Design Statement

Havant Care Home
Application Query - Additional Information

22.08.2024
Job no. A-1014

Anavo Developments Limited

1.1 North Elevation

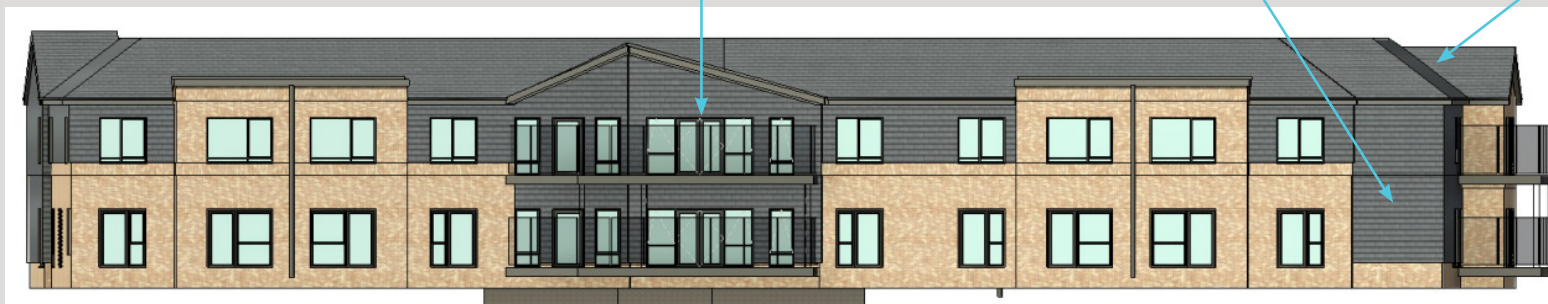
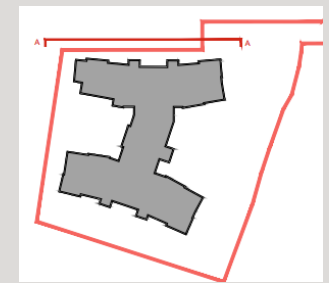
Glazed guarding has been raised to 1800mm from 1100mm following safety requirements

Escape door from stairs relocated and shown on west elevation

Gable end removed for roof build-ability

Balcony height has been increased to 1800mm to follow safety requirements for care homes

The fire escape door from the stairs has been relocated to the west elevation of the building, this can be seen in the west elevation drawing. The proposed north elevation drawing shows that the escape door has been removed in this location and the vertical cladding has been continued.

1.3 East Elevation

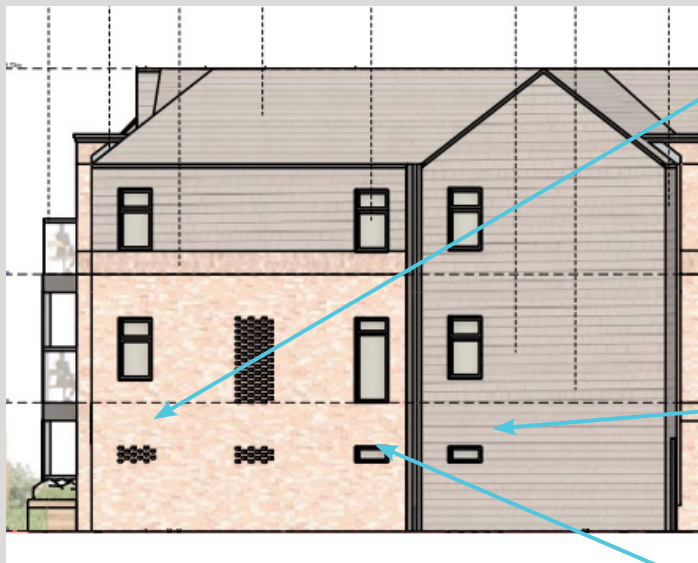
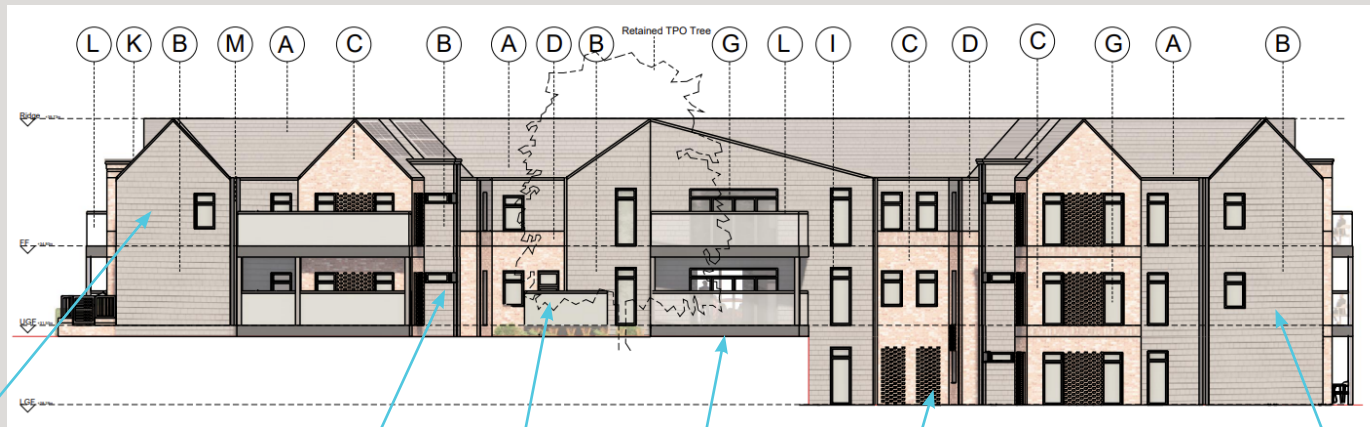
- Window added to bedroom
- Window length increased to allow more natural light into destination end
- Escape door relocated
- Green roof removed from entrance

An additional window has been proposed on the east elevation. The additional window has been added to a bedroom, which will provide the living space with more natural light.

The window in this area has been replaced with the fire escape door from the stairs in this area. The escape door is originally seen on the north sectional elevation and has been moved to the east elevation.

The window has been increased on the south elevation to allow more natural light into the residents corridor.

Approved West Elevation zoomed in section of gable ends

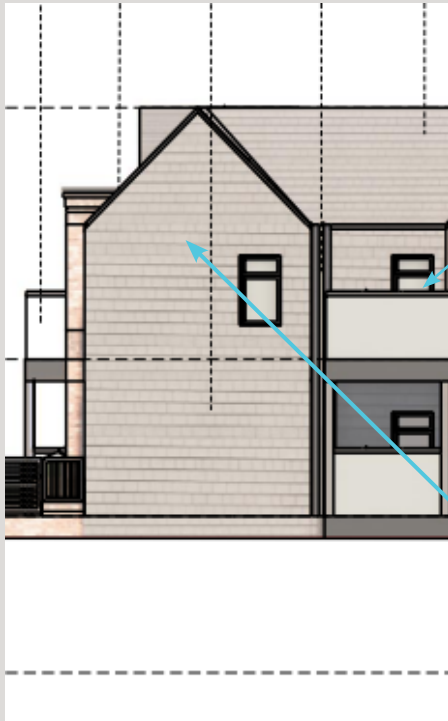
Glazed guarding raised from 1100mm to 1800mm for safety requirements

Proposed West Elevation zoomed in section of removed gable ends

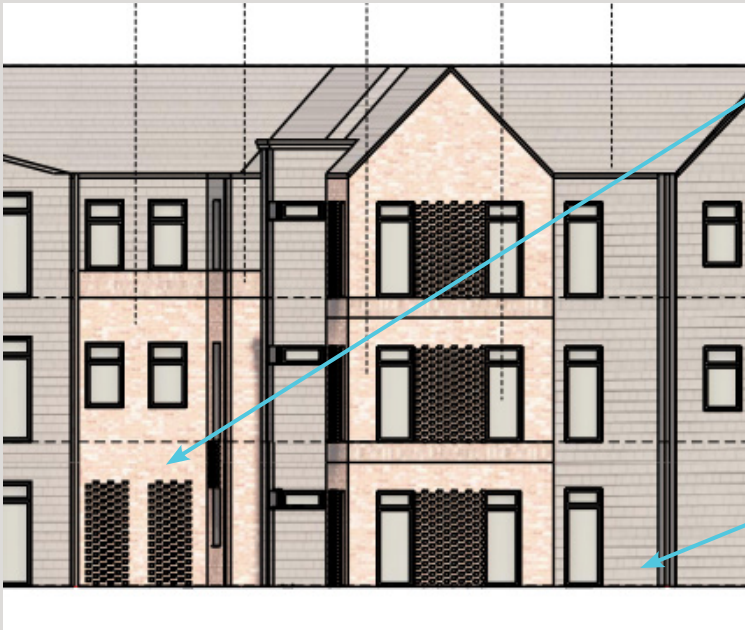
The gable ends which are shown on the west elevation have been removed in the proposed elevation. This has been done to allow for easier roof buildability.

Proposed West Elevation zoomed in showing window added and extruded brick removed and relocated fire escape door

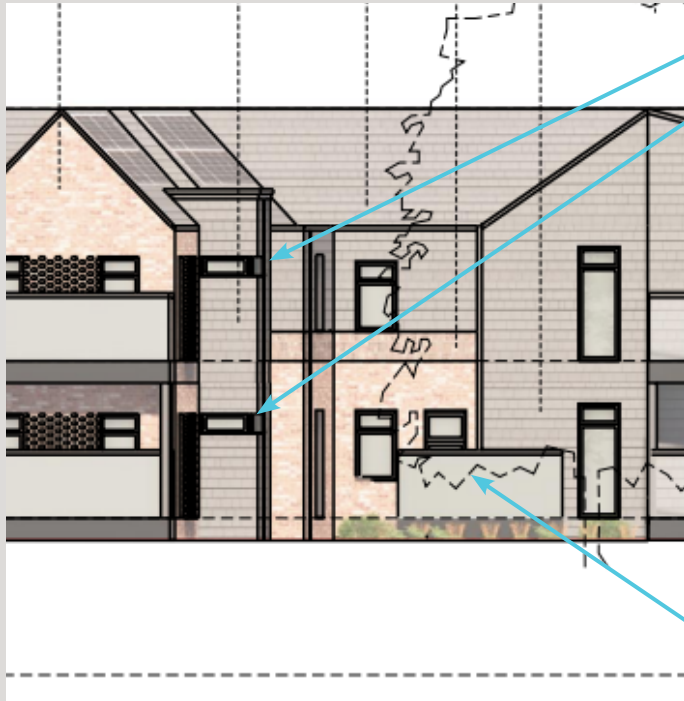
The extruded brick has been removed from the west elevation in this area to allow for a window to be added to the kitchen office. The extruded brick has been removed in this area to continue the character of the elevation in this area.

The fire escape door has been relocated on the proposed west elevation. This fire escape door was originally on the approved southern elevation, but has been moved to the west elevation due to the layout of the stairs and the fire strategy

Proposed West Elevation zoomed in section showing removed windows from en-suites and single door replaced with double door

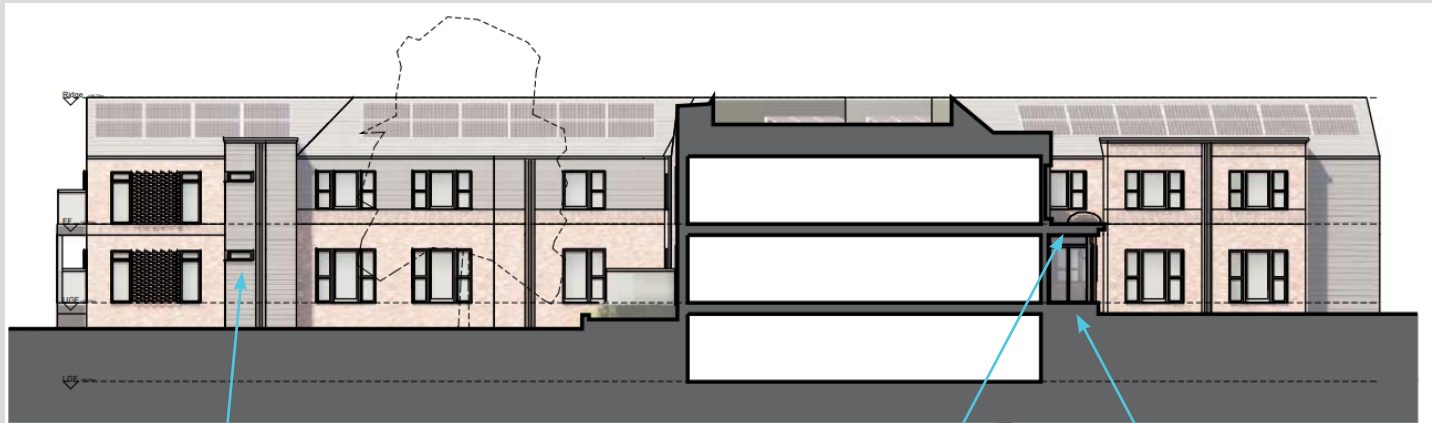
The windows have been removed from the en-suites in the approved west elevation. The vertical cladding has been continued in the proposed west elevation where the windows have been removed. This has been done to continue the character of development, as there are no other en-suites with windows.

The single door on the west elevation has been replaced with a double door. The door in the approved drawings opens from the day center. In the proposed drawings this has been changed to the private dining area. The double door has been added to allow from light into the space and a view over the garden from the private dining area.

Approved Sectional Elevation south zoomed in to see the en-suite windows

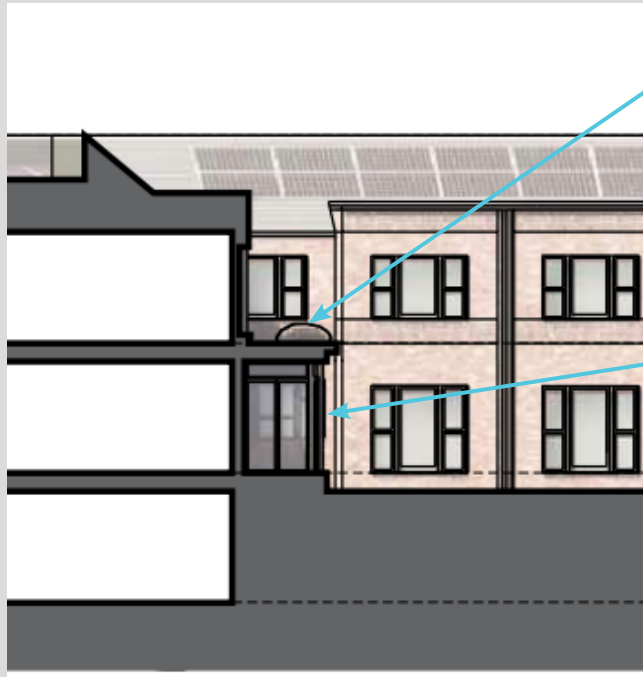
The windows have been removed from the en-suites in the approved west elevation. The vertical cladding has been continued in the proposed west elevation where the windows have been removed. This has been done to continue the character of development, as there are no other en-suites with windows.

1.6 Sectional Elevation North

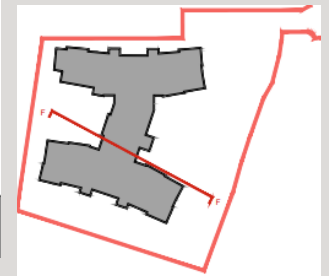
Escape door from stair relocated, proposed east elevation shows new position

Green roof removed from entrance

Windows removed from entrance lobby

Windows changed to top hung windows

Windows removed from ensuite

Single door changed to larger door with window panel

Proposed Sectional Elevation south zoomed in to see the quiet lounge on the lower ground floor

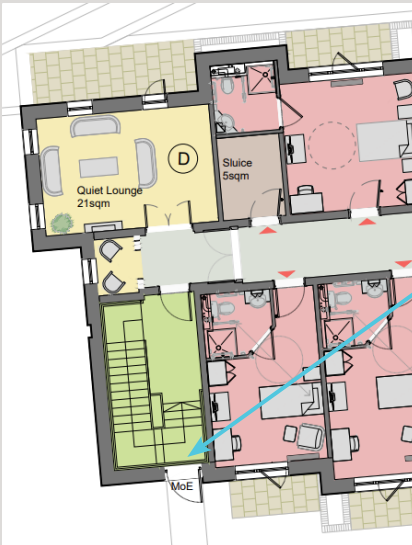
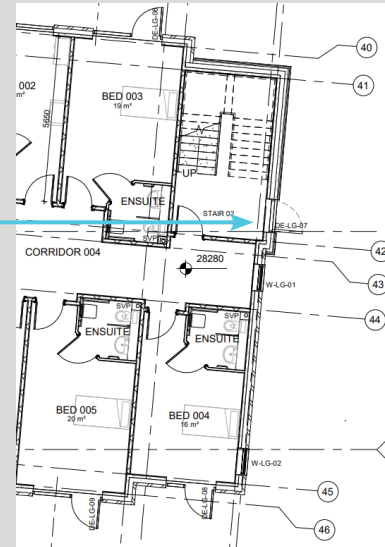
The windows have been removed from the en-suites in the proposed west elevation. The vertical cladding has been continued in the proposed west elevation where the windows have been removed.

The single door to the quiet lounge has been increased from a single door to a single door with a window. This will allow more light into the quiet lounge, this has been added due to the rooks northern facing windows.

1.7 Lower Ground Floor

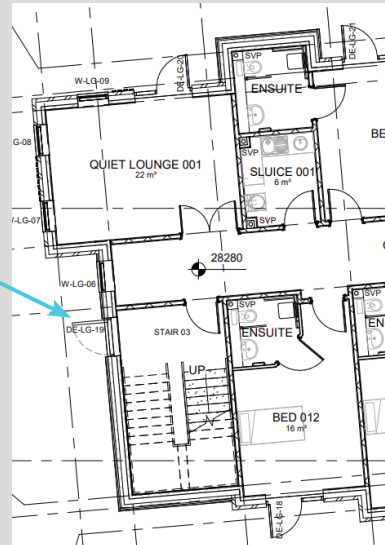
The fire escape door has been relocated on the lower ground floor to the east of the wing. The door has been relocated from the approved sectional elevation south drawing to the proposed east elevation on the lower ground floor. This is due to the fire regulations and stair regulations

The fire escape door has been relocated on the lower ground floor to the west of the wing. The door has been relocated from the approved south elevation to the proposed west elevation on the lower ground floor. This is due to the fire regulations and stair regulations

1.8 Upper Ground Floor

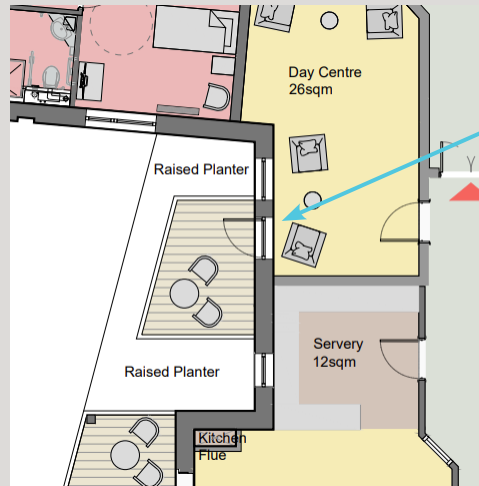
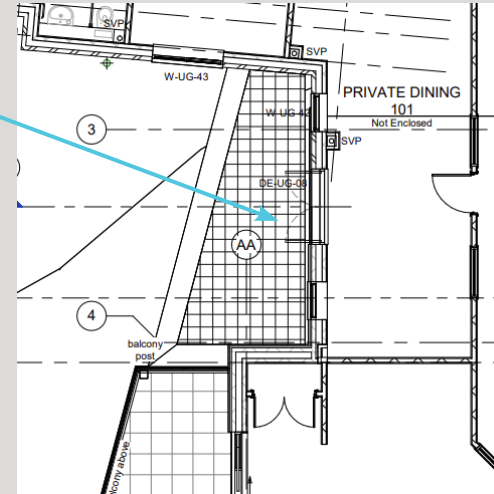
The day center and servery have been proposed to be replaced with the private dining on the upper ground floor. The single door to this area has been replaced with a double door, which can be seen on the proposed west elevation. The patio area from this space is still present, and can be seen on the landscape site plan.

The fire escape door has been relocated on the upper ground floor to the east of the northern wing. The door has been relocated from the approved north elevation to the proposed west elevation on the upper ground floor. This is due to the fire strategy and the stair design. This can be seen on the proposed west elevation

1.9 Bin and Cycle Store

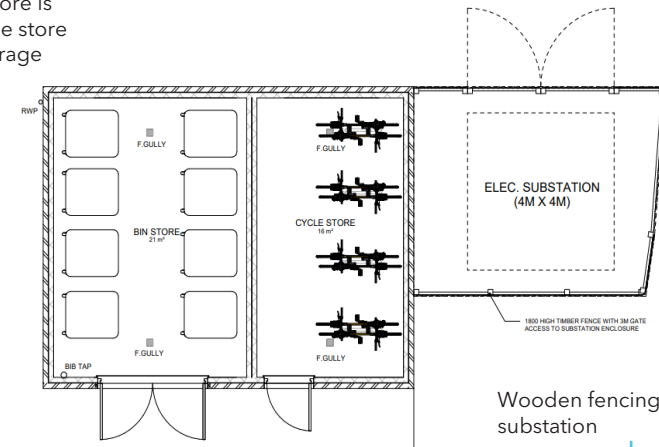
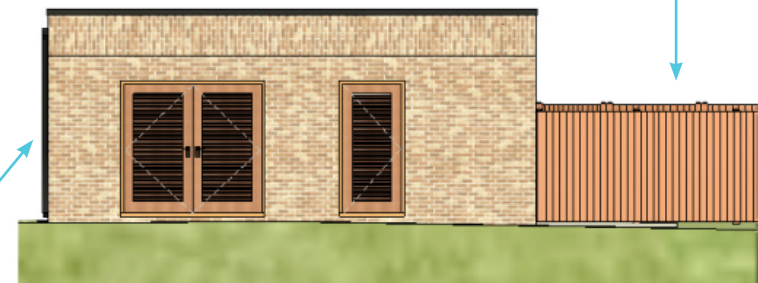
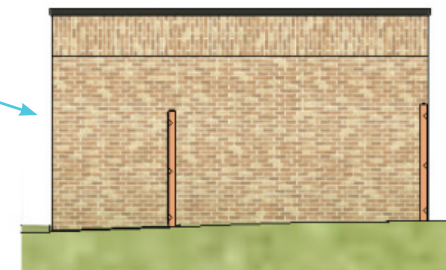
Bin and cycle store size has been changed to accommodate new substation.
The new size of the store is 5.8m x 7.6m. The cycle store continues to have storage space for 8 bicycles

New substation located next to approved bin and cycle store.

Wooden fencing surround to substation

Bin and cycle store has increased in length and decreased in width
